REMARKS

Claims 1-6 and 11-19 are pending in this application. Claims 7-10 have been deleted. Claims 1 and 3 are independent. Claims 2, 11-14 depend from claim 1. Claims 4-6 and 15-19 depend from claim 3.

Fig 1

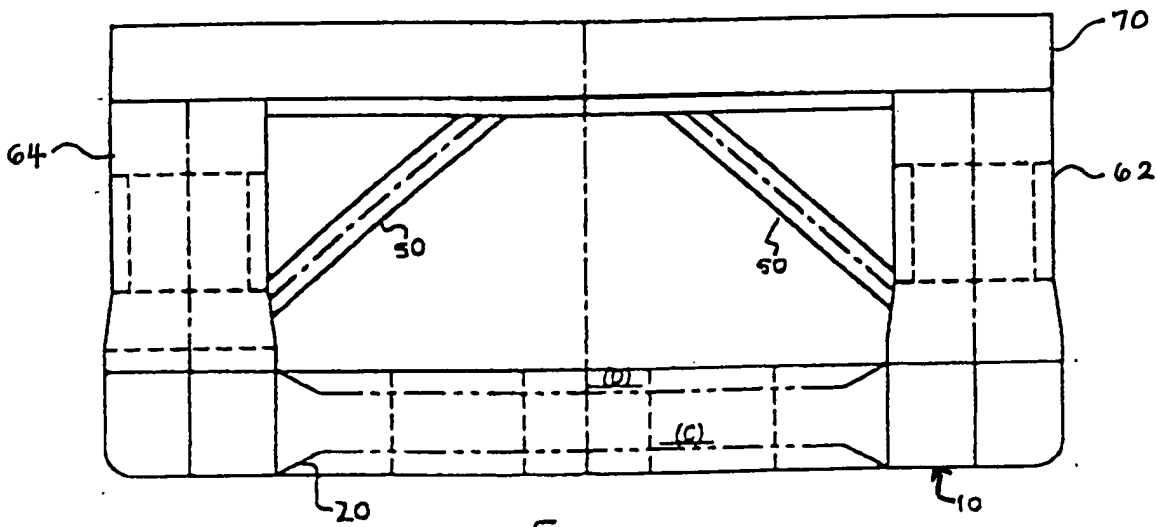
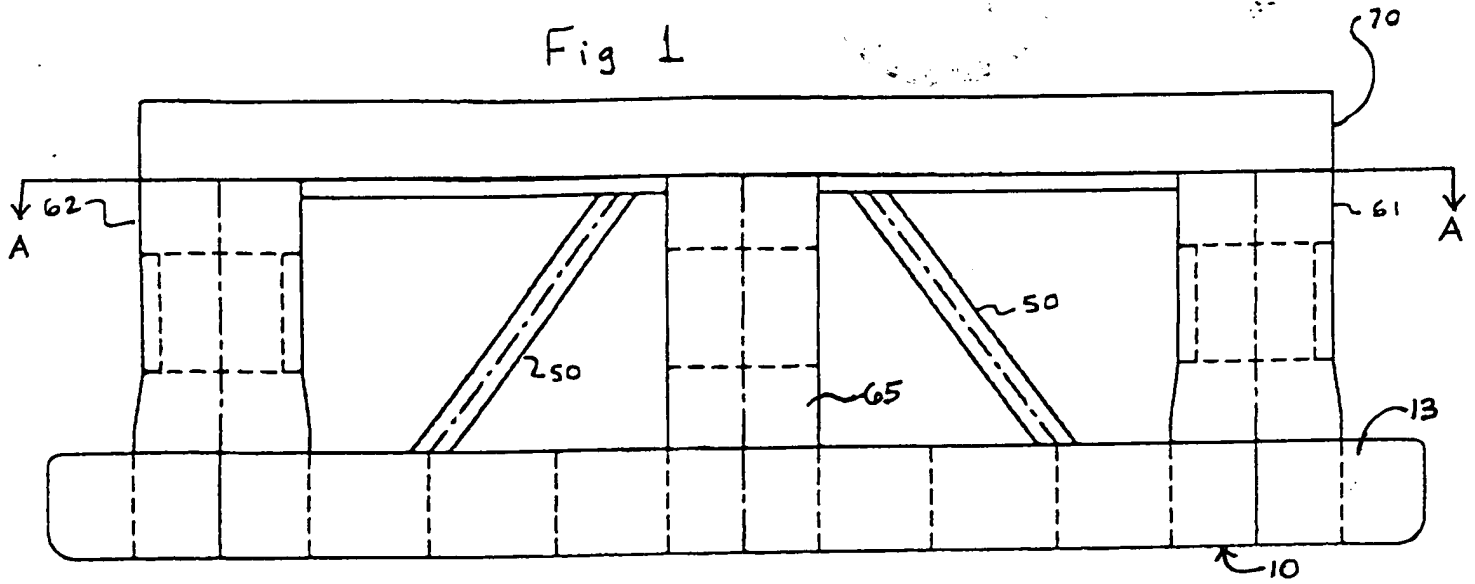
The Examiner objected to the drawings of Figures 1, 2, 5, 8, 9, and 10 because of missing section lines, improper lead lines, and missing reference numerals. The drawings of Figures 1, 2, 5, 8, 9, and 10 have been amended to include the missing section lines and reference numerals and to correct the improper lead lines. Accordingly, withdrawal of this objection is requested. Figures 3, 6, and 7 have also been amended to include missing reference numerals. Applicants believe that this amendment will facilitate understanding of the disclosure. Subsequent to the Examiner's approval, formal replacement sheets for Figures 1-3 and 5-10 incorporating these changes will be submitted to the office.

Not
app.
5/17/99
